# UNITED STATES PATENT AND TRADEMARK OFFICE

APPLICATION NO.	FILING DATE	FIRST NAMED INVENTOR	ATTORNEY DOCKET NO.	CONFIRMATION NO.
09/662,209	09/14/2000	Bruno Acklin	P00,1314	5877

# Office Action Summary

## **DETAILED ACTION**

**FIG. 1**

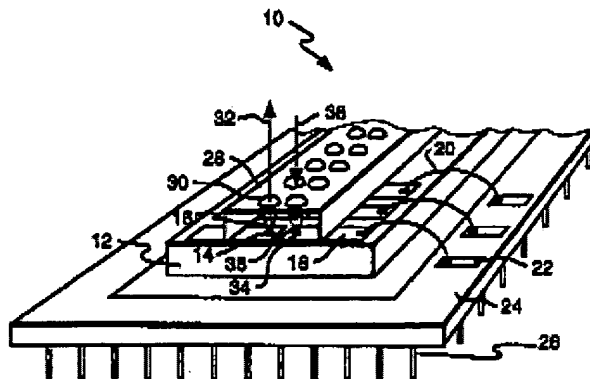
Claims 1,2,3,5,6,8,9,15,16 and 20-22 are rejected under 35 U.S.C. 102(b) as being anticipated by Jewell et al (PN 5,500,540).

Figure 1 illustrates an array of lasers having an optoelectronic chip (12) where the array of lasers are carried, an optical chip (28), which covers the array of lasers with an optical element (30) where the laser beam emits. A wire bond (20) electrically connects the laser to a terminal pin (26). Pins (26) are connected through macroscopic package (24) where optical chip is mounted.

**FIG. 5**

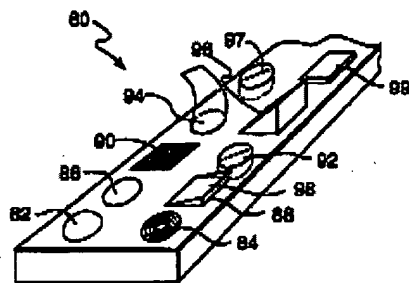
Figure 5 illustrates an optical chip (80) having optical elements, which may be used in place of optical chip (28), as disclosed in column 8 lines 23-49.

FIG. 11

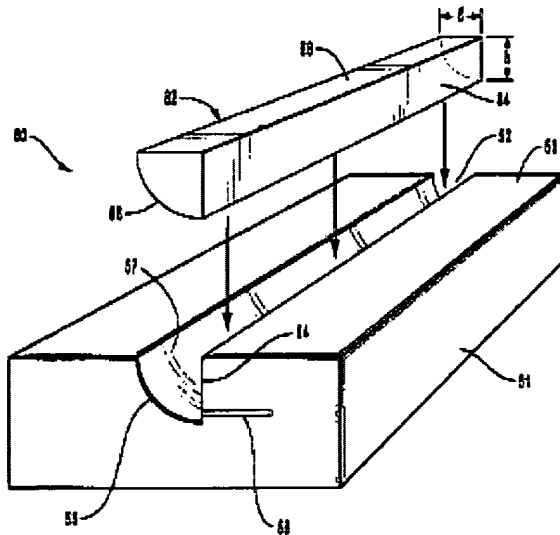
Claims 4, 7 and 10 are rejected under 35 U.S.C. 103(a) as being unpatentable over Jewell et al (PN 5,500,540) in view of Hwu et al (6,259,713).

Jewell et al does not disclose a ceramic carrier having a mirrored surface or a recess within the carrier.

Hwu et al illustrates in figures 11 and 12 a ceramic substrates having a recess within the substrate and having a mirrored surface on the ceramic substrate where a transparent optical element is placed within the recess which includes the mirrored surface to reflect the laser beams of the diode laser array towards a transparent flat surface which covers the entire recess. In column 11 lines 18-25 discloses using ceramic substrates are highly thermally conductive.

Therefore, it would have been obvious to a person having ordinary skill in the art to use a ceramic substrate as taught by Hwu et al because it would improve heat dissipation of the laser beams.

**F I G. 1**

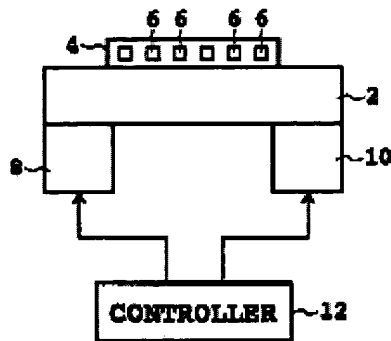
Claims 17-19 are rejected under 35 U.S.C. 103(a) as being unpatentable over Yamamoto et al (PN 6,038,242).

The use of Peltier elements to provide cooling or temperature control to the substrates of laser system is well known in the laser art as shown in figure 1.
